Bureau of Engineering
Report No. 2

REVISE BUDGET AND ISSUE SUPPLEMENTAL AGREEMENT CHANGE ORDER NO. 12 TO SJD&B, INC. FOR THE CAPITAL IMPROVEMENT PROJECT 8654 DONALD C. TILLMAN WATER RECLAMATION PLANT JAPANESE GARDEN AMERICANS WITH DISABILITY ACT COMPLIANCE (WORK ORDER NO. SJD00013, CONTRACT NO. C-139694)

PRELIMINARY CHANGE ORDER

Figure No. 2: Waterfall Viewing Bridge

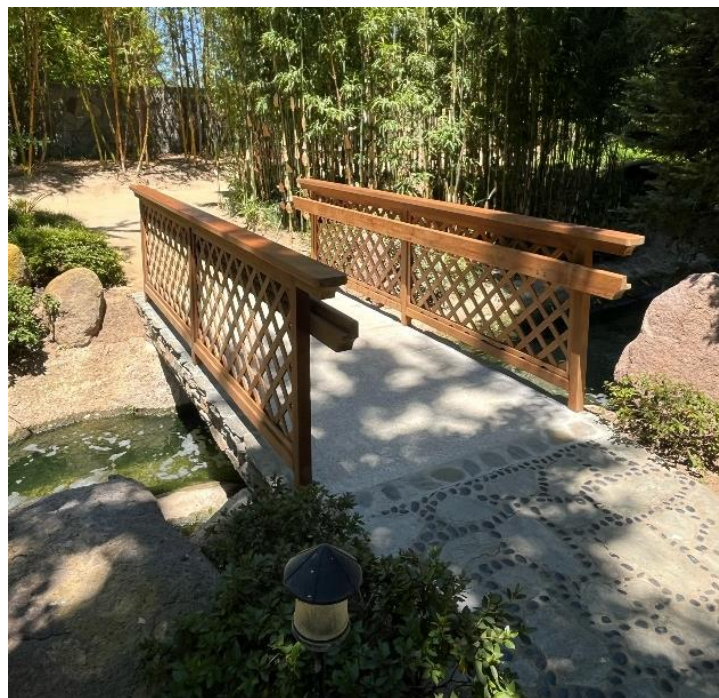
During the demolition of the Waterfall Viewing Bridge, electrical conduits were discovered underneath that were not shown in the project plans. The BCA electrical inspector determined that the conduits needed replacement. Additionally, the existing bridge footings were found to be lower in elevation than specified in the plans, requiring an extension of the footings. This requires a change order with an estimated cost of \$50,000.
